STANDARD FIELD SERVICE BULLETIN

FSB Number	CHRAEFSB2018-12
Author	Tony Bryan
Date	04/02/2018
Subject	Moto G6 Play - Intermittent Mic Audio (mic diaphragm stuck)
Model Affected	XT1922-1/2/3/4/5/10 (ROW Models Only)
Level Of Repairs	Level 3

Figure 1.0 -MEMS Supplier - "High Risk" Material Identification

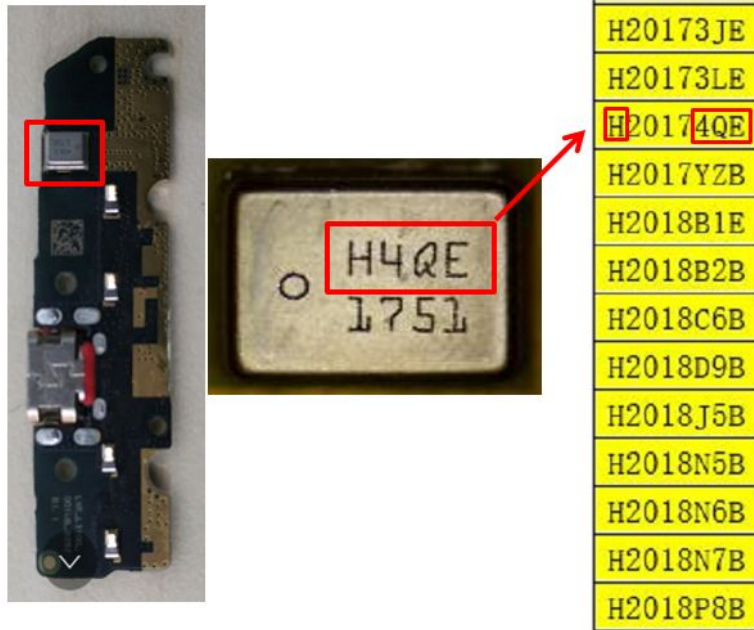
Short-Term: The affected microphone supplier (MEMS) has implemented process improvements to help prevent this issue lot codes. See Figure 1.0 below to identify “High-Risk” material fabricated prior to supplier process improvements.

1. Following the Service Manual, carefully disassemble the device to gain access to the Sub-PCBA where the Primary Microphone (p/n: S938C29034) component is placed.
2. Inspect the part markings on the Primary Microphone (p/n: S938C29034) component to determine if it listed as ‘High Risk’ in Figure 1.0 above.
3. If the lot code shown is listed as “High-Risk”, then either replace the Primary Microphone (p/n: S938C29034) component or swap the Sub-PCBA (p/n: SP68Cxxxxx).
4. Perform standard functional testing on device to confirm customer’s original “Mic Audio” related complaint.
 - a. If an audio issue is confirmed, then follow normal troubleshooting steps to determine the problem and repair the device.

Figure 2.0 - 2nd Microphone Supplier (KNOWLES) - Change Details

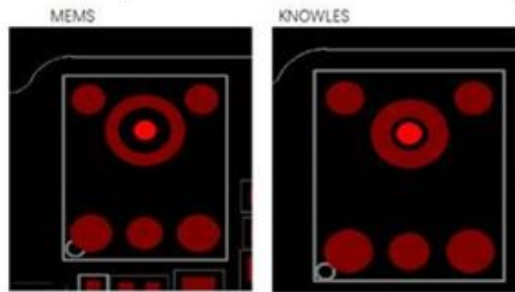
Long-Term: Motorola is currently qualifying a 2nd supplier (KNOWLES) for the Microphone component. Due to a solder mask difference between the two suppliers, this will require a layout change to both the Main-PCB and Sub-PCB. The part numbers printed on the Main-PCB and Sub-PCB will also be updated to reflect this change. Please see details below in Figure 2.0. This will be completed as a running change with a estimated implementation date of June 2018.

There is a difference in the solder mask between the two microphone suppliers, as shown in image above.

Main PCB and Sub PCB part numbers will change to support Mic Supplier 2 (KNOWLES) as shown below.

Sub PCB: LLDB310 REV. C1-6 (shown)
 Mic Supplier 1 (MEMS) = LLDB310 REV. C5-6
 Mic Supplier 2 (KNOWLES) = LLDB310 REV. C6-6

Main PCB: LLDM310 REV. B7-6 (shown)
 Mic Supplier 1 (MEMS) = LLDM310 REV. B8-6
 Mic Supplier 2 (KNOWLES) = LLDM310 REV. B9-7

Issue Screen Method (Phone-Level)

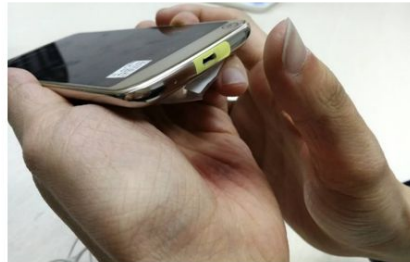
B. Service should implement the Phone-Level Test Screen method shown below, on Moto G6 Play (ROW) devices regardless of complaint, as an outgoing quality measure to catch intermittent primary microphone audio issues.

- a) Insert the headphone into the device and have the operator to wear the headphone.
- b) Dial: ***##*#2486#*##***
- c) Enter Audio Loopback mode: CQA menu→Audio→MIC Loopback→Primary MIC
- d) Carry the phone as picture below and press with thumb to cover the MIC hole. The frequency is once per second.
- e) Judge the function by if the tester can hear the sound. If it's function then keep pressing action till 100 times. And sort out if once no sound during 100 times.
